Title - Sujet Simulator/Workshop Building	
Solicitation No. - N° de l'invitation F1700-110664/A	Amendment No. - N° modif. 001
Client Reference No. - N° de référence du client F1700-110664	Date 2012-05-29
GETS Reference No. - N° de référence de SEAG PW-\$PWY-020-6701	
File No. - N° de dossier PWY-2-35032 (020)	CCC No./N° CCC - FMS No./N° VME
Solicitation Closes - L'invitation prend fin at - à 02:00 PM on - le 2012-06-26	Time Zone Fuseau horaire Pacific Daylight Saving Time PDT
F.O.B. - F.A.B. Plant-Usine: <input type="checkbox"/> Destination: <input checked="" type="checkbox"/> Other-Autre: <input type="checkbox"/>	
Address Enquiries to: - Adresser toutes questions à: Ly, Ronny(PWY)	Buyer Id - Id de l'acheteur pwy020
Telephone No. - N° de téléphone (604) 666-0043 ()	FAX No. - N° de FAX (604) 775-6633
Destination - of Goods, Services, and Construction: Destination - des biens, services et construction: DFO - Coast Guard Station - Bamfield, B.C.

Please find Addendum #1 herein.

TITLE:
**SIMULATOR/WORKSHOP BUILDING
COAST GUARD STATION
ADDENDUM**

PARTIAL SITE PLAN A1.1 -STEPS TO DRIVEWAY

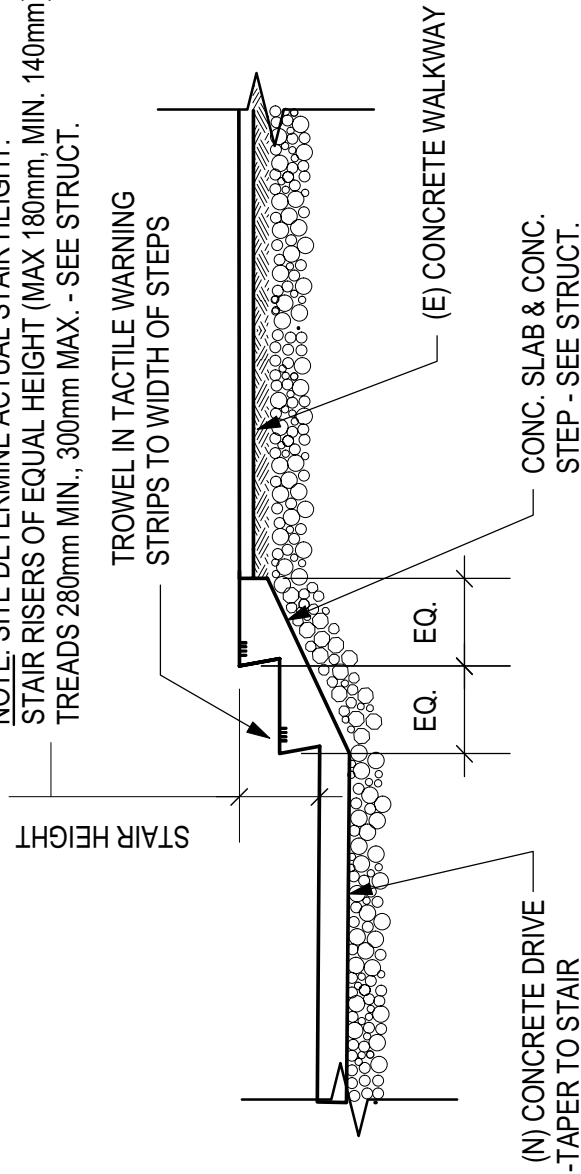
.1 See attached drawing ASK-01 for detail of steps from existing sidewalk down to the new driveway. Site determine actual stair height and confirm with NTAG and Structural before construction.

NOTE: SITE DETERMINE ACTUAL STAIR HEIGHT.
STAIR RISERS OF EQUAL HEIGHT (MAX 180mm, MIN. 140mm)
TREADS 280mm MIN., 300mm MAX. - SEE STRUCT.

PARTIAL SITE PLAN A1.1 -PATH

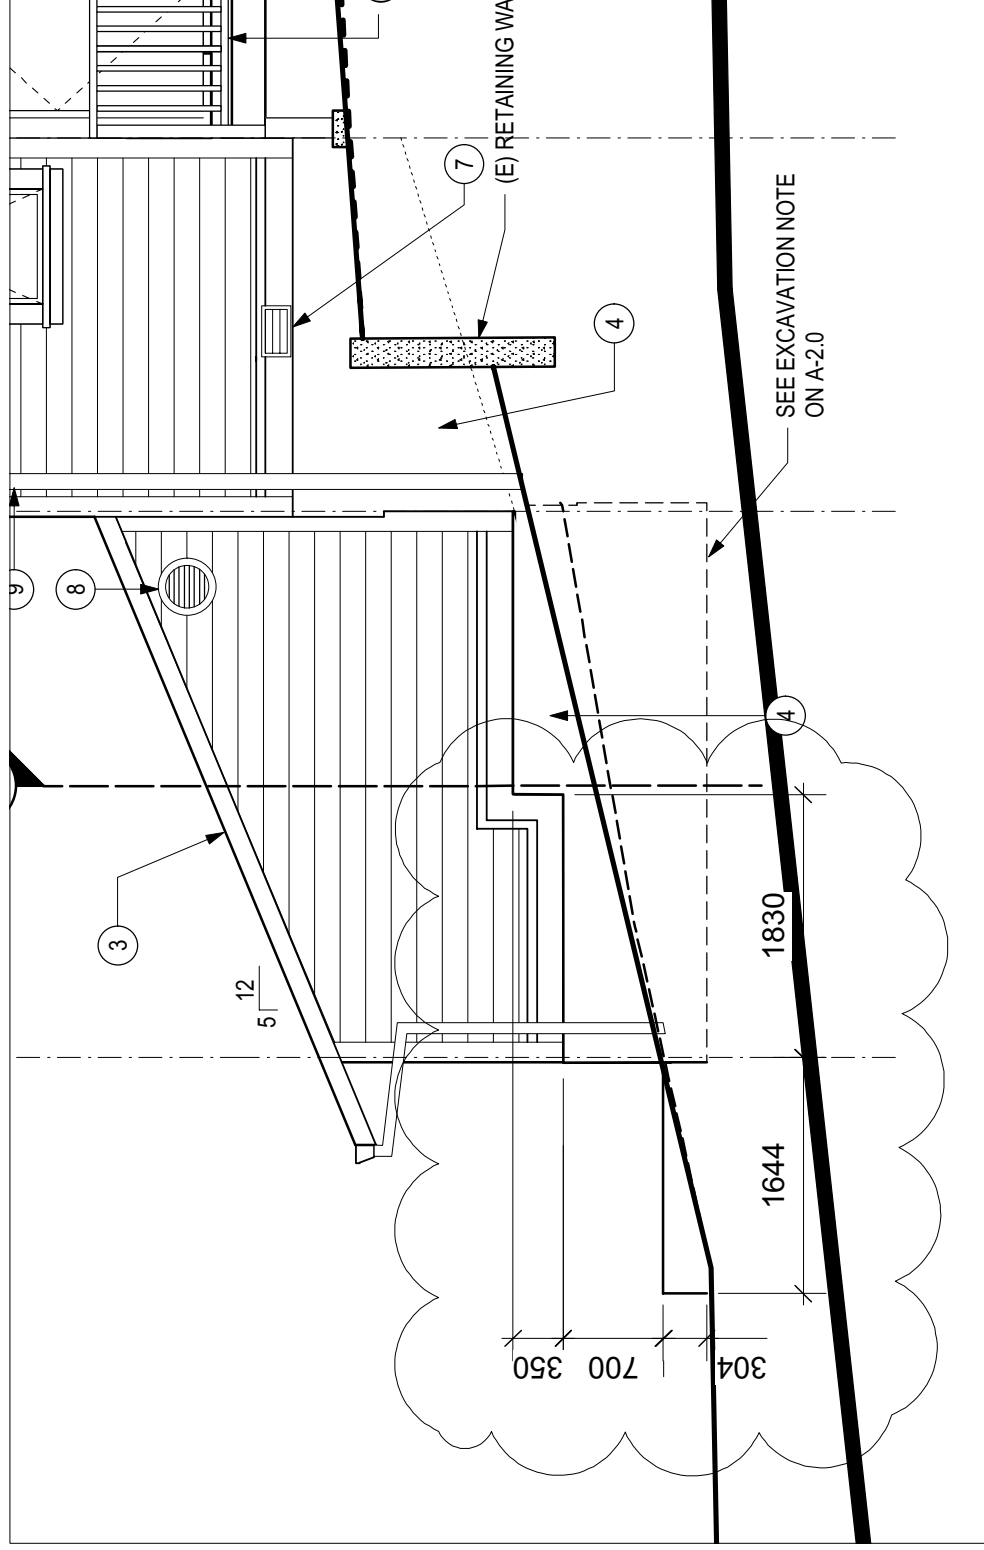
.2 Gravel path and concrete retaining wall are not included in tender contract. Gravel path as shown is existing. See ASK-02.

.1 Delete retaining wall and gravel path. See ASK-02

UPPER FLOOR/LOW ROOF PART PLAN

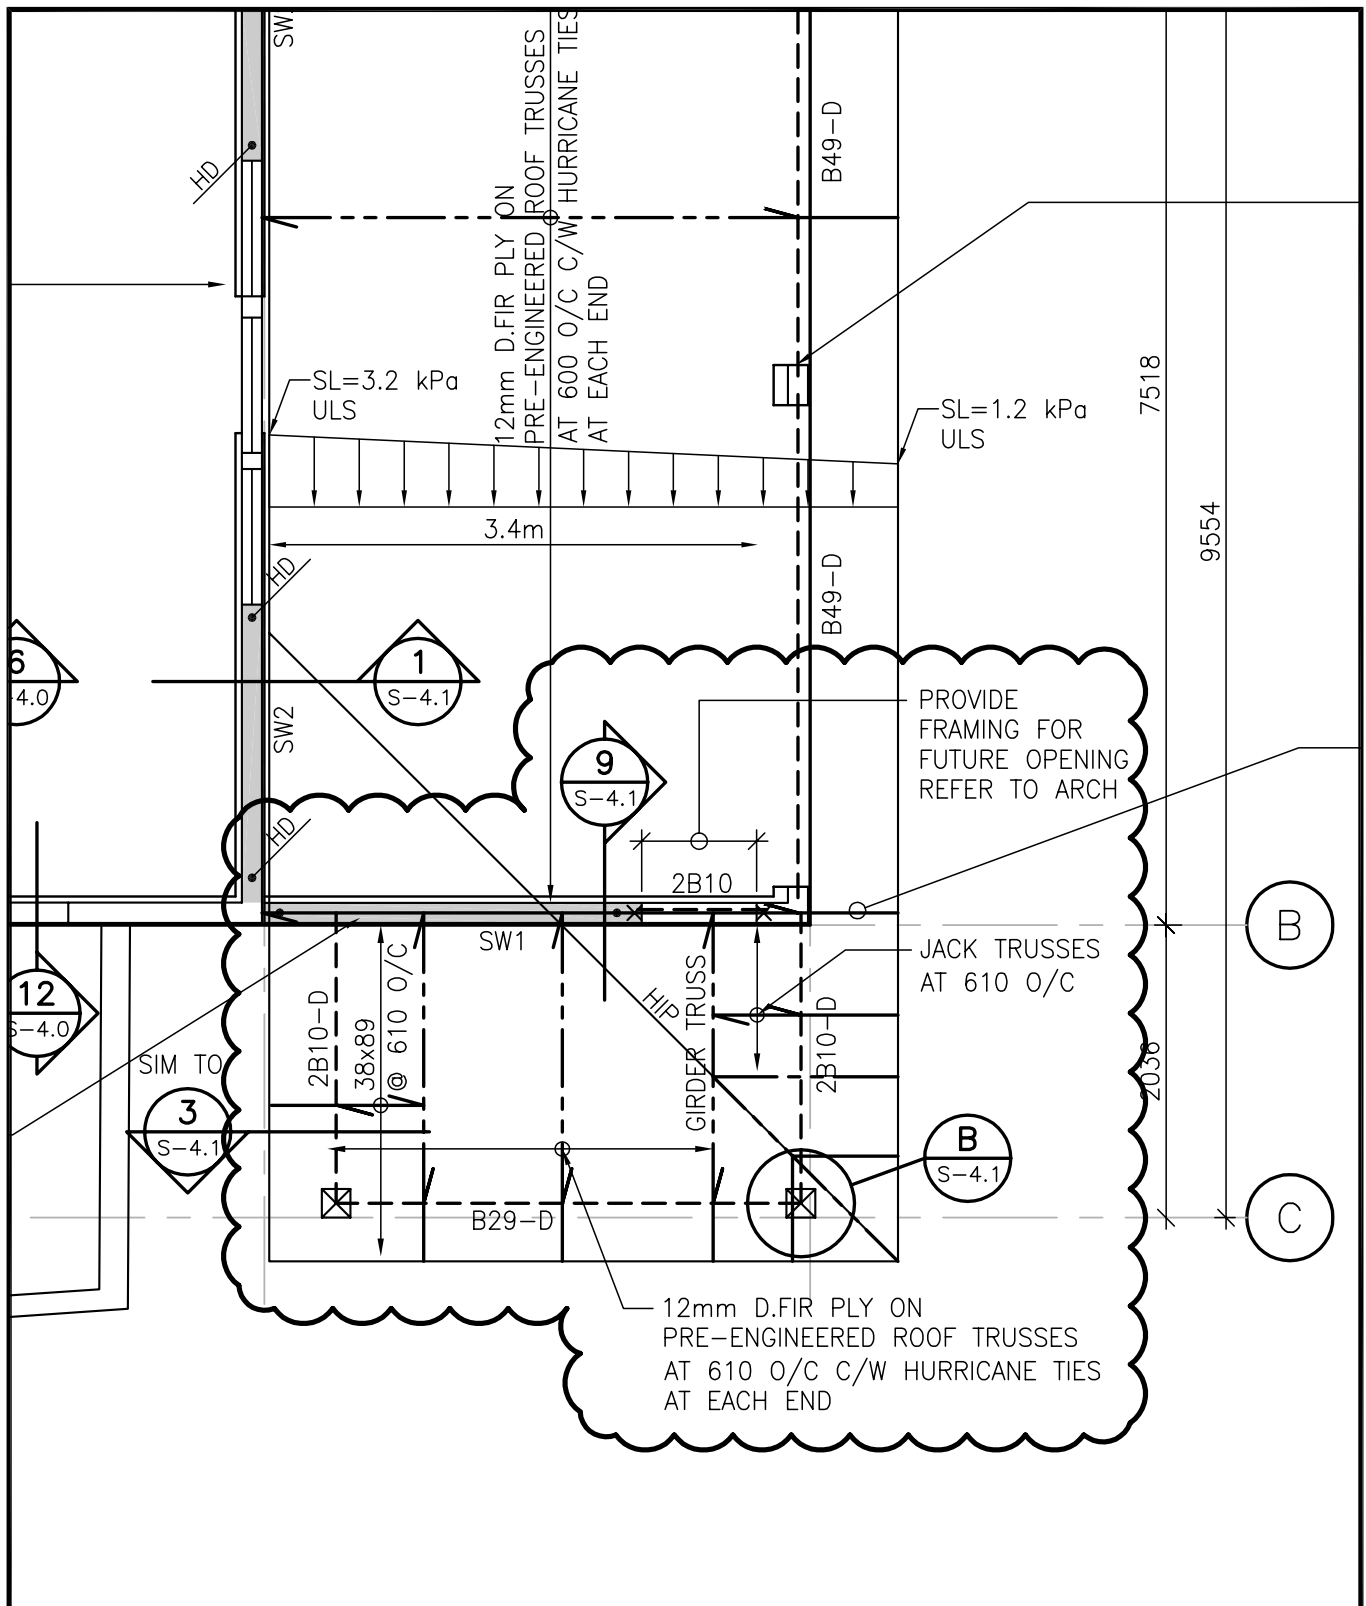
1. On 1/S-2.1 DELETE pressure treatment requirement noted by (*) for 2B10 along Grid A
2. Roof framing on 2/S-2.1 from Grid 4 to 5 and C to B to be REPLACED with details shown on SSK1.
3. REPLACE section 7/S-4.0 shown at Grid B/3+ and Grid A/3+ with 12/S-4.0 as shown on SSK2.
4. REPLACE section 1/S-4.0 at Grid B/4+ with 9/S-4.1 as shown on SSK6.
5. ADD SW1 text to shearwall along Grid A at 4+.

REVISED & NEW SECTION

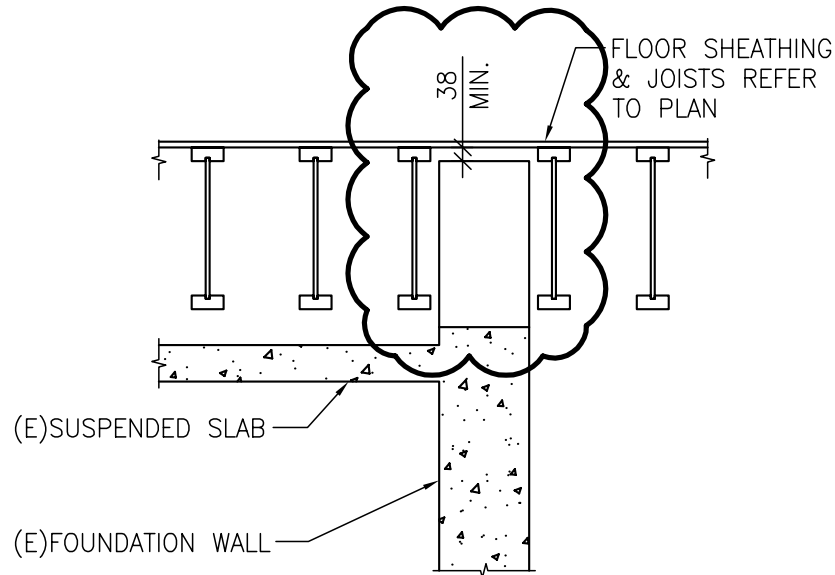
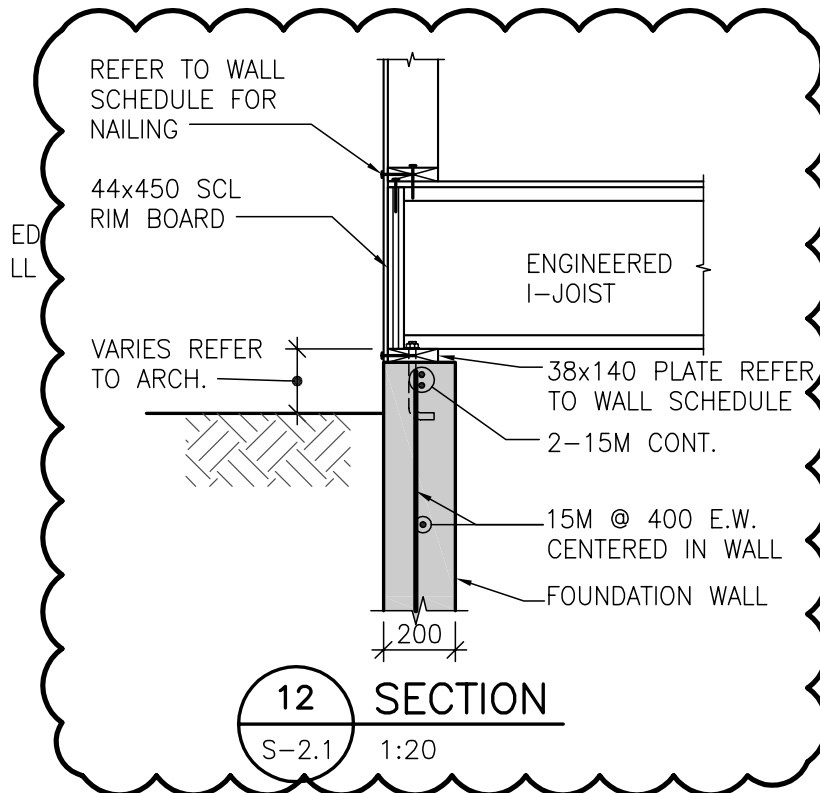
1. Section 1/S-2-0; block at upper floor REPLACE reference from 1/S2.1 to 1/S4.1
2. Section 4/S-2.0; ADD exterior concrete driveway to section.
3. Section 6/S-2.1; Provide gap between existing wall and TJI joist as per detail shown on SSK2.
4. DELETE section 9/S-2.0 and 10/S-2.0.

TYPICAL HOLD-DOWN DETAILS

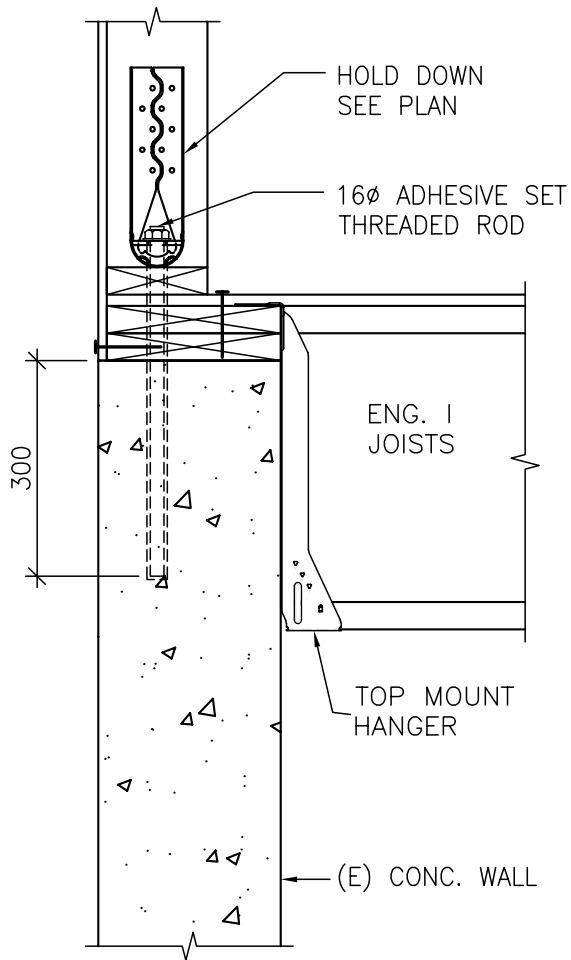
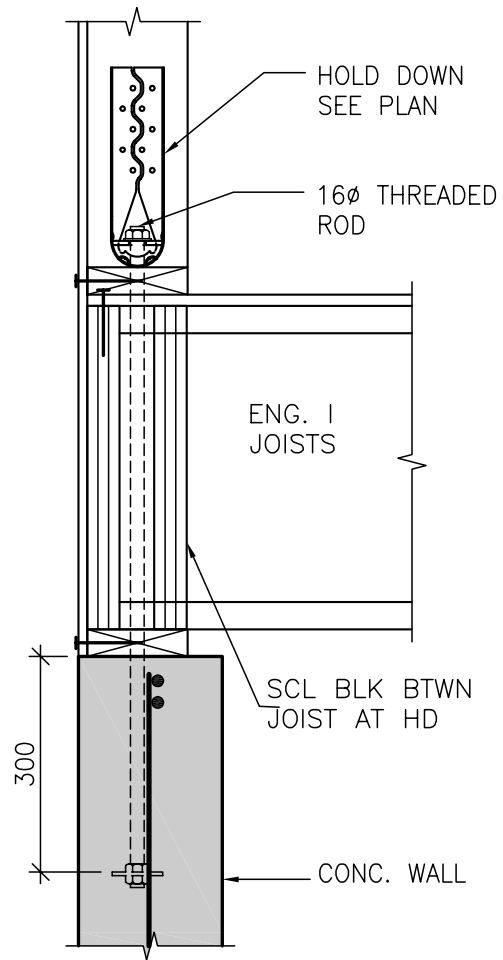
1. Section 2/S-2.1;
 1. Roof slope varies, see arch for details,
 2. Truss heel height of 300mm at outside face of wall,
 3. ADD 38x140 cont fascia board.
 2. ADD detail 8/S-4.1 and 9/S-4.1 hold-down details as shown on SSK3.
 3. REVISE section 2/S-2.1 as indicated on SSK4
 4. REVISE section 3/S-2.1 as indicated on SSK5
-

.2 Site Plan:

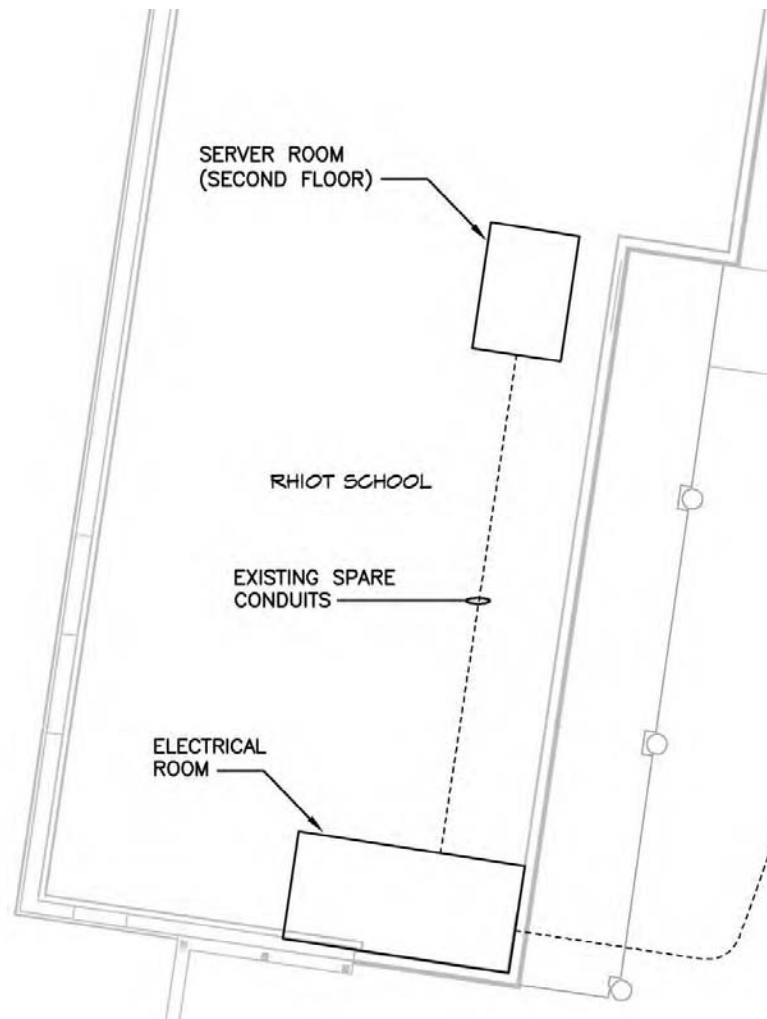
- .1 Revise note 1 to read:
" Intercept existing conduits. Extend one 53mm conduit for power and one 78mm conduit for communications to new building. Coordinate exact locations on site. **Obtain existing site drawings from PWGSC for coordination of site services.** "
- .2 Refer to detail below for location of RHIOT school server room.

2. Drawing E2 - Lower Floor and Main Floor Electrical Layouts

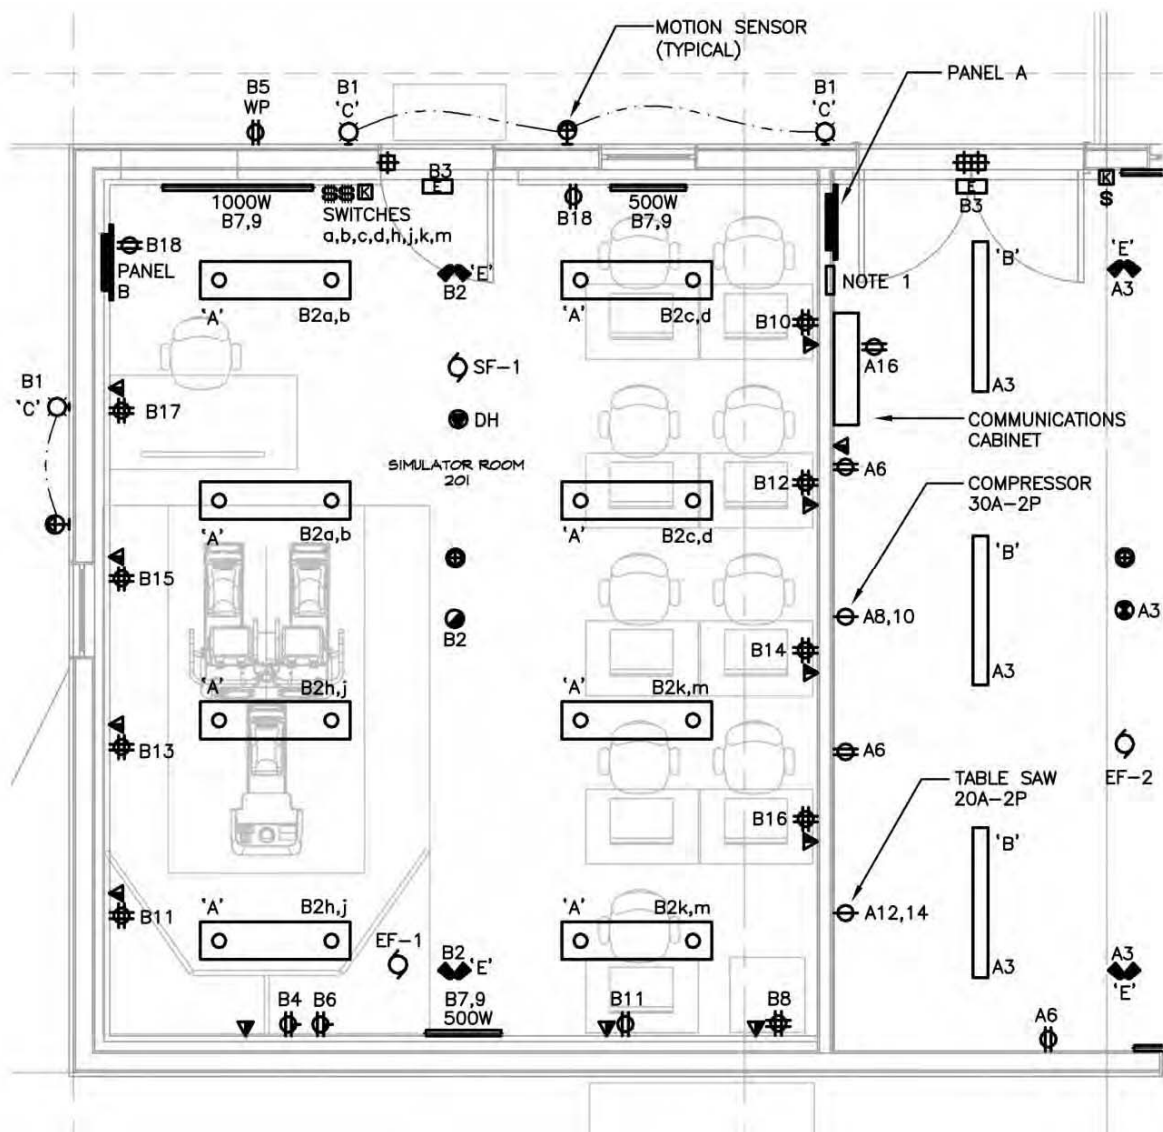
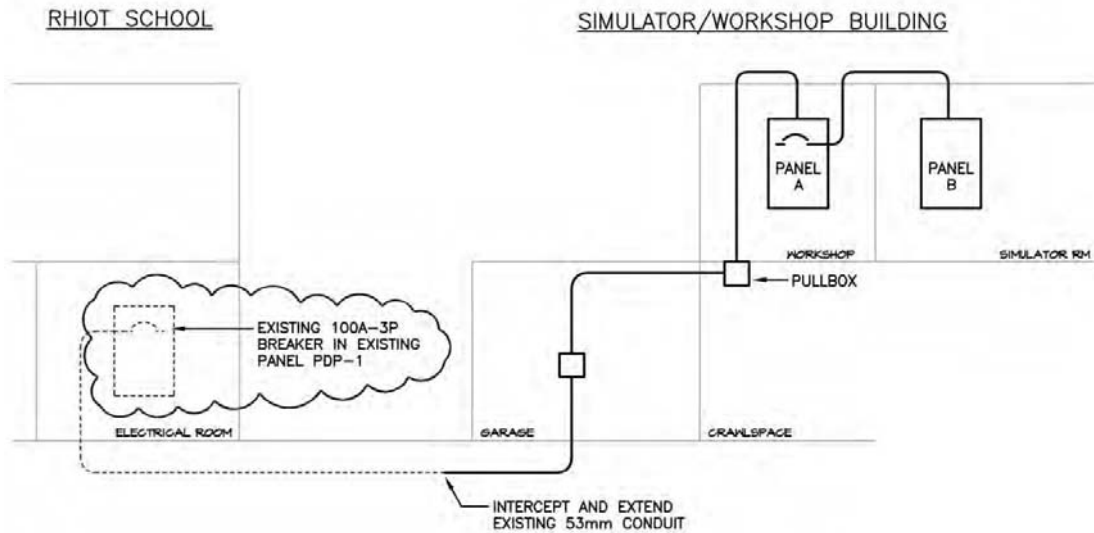
- .1 Lower Floor Electrical Layout:
 .1 Provide motion sensor for control of two type C luminaires. Locate motion sensor on exterior wall along gridline 5 between doors.
- .2 Main Floor Electrical Layout: Refer to revised layout below for the following.
 .1 Provide two exterior motion sensors to control type 'C' luminaires as shown.
 .2 Revise communications cabinet to surface mounted cabinet, 914mm x 914mm x 200mm.
 .3 Delete dimmers in simulator room and provide eight switches for step dimming of type 'A' luminaires.

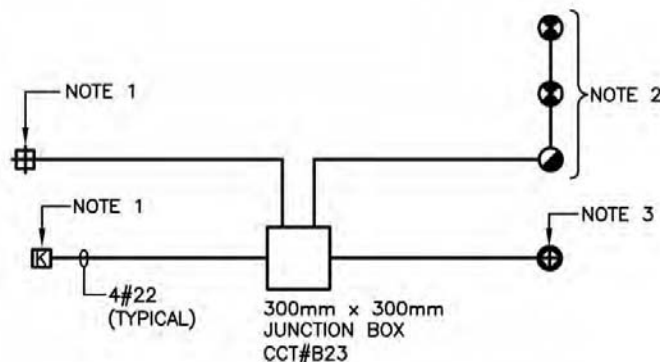
- .1 Communications Riser Detail:
- .1 Revise note as follows:
" Intercept and extend existing 78mm conduit. Provide **25 pair CAT5e** cable and 6 fibre multimode cable from RHIOT school server room to communications cabinet. **Cables to be outdoor rated.** "
 - .2 Add new note as follows:
" Provide patch panels in RHIOT school server room and terminate fibre and CAT5e cables from simulator building. "
- .2 Security Riser Detail: Revise as indicated below:

1. PROVIDE 2 GANG BOX WITH COVERPLATE AT LOCATIONS INDICATED ON PLANS. PROVIDE WIRING AND COIL 300mm FOR FUTURE CONNECTION OF SECURITY SYSTEM DEVICES.
2. PROVIDE SMOKE AND HEAT ALARMS COMPLETE WITH AUXILIARY RELAY FOR CONNECTION TO FUTURE SECURITY SYSTEM. INTERCONNECT DEVICES AND WIRE TO LIGHTING CIRCUIT AHEAD OF SWITCH.
3. PROVIDE WIRING TO LOCATIONS INDICATED ON PLANS AND COIL 2m IN CEILING SPACE. IDENTIFY LOCATION FOR FUTURE CONNECTION WITH CEILING STICKER.

6
E3

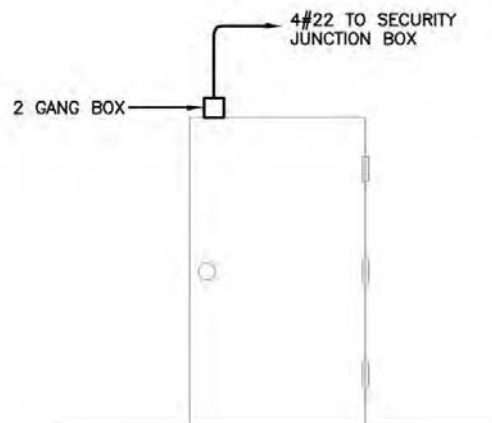
.5 Add the following detail:
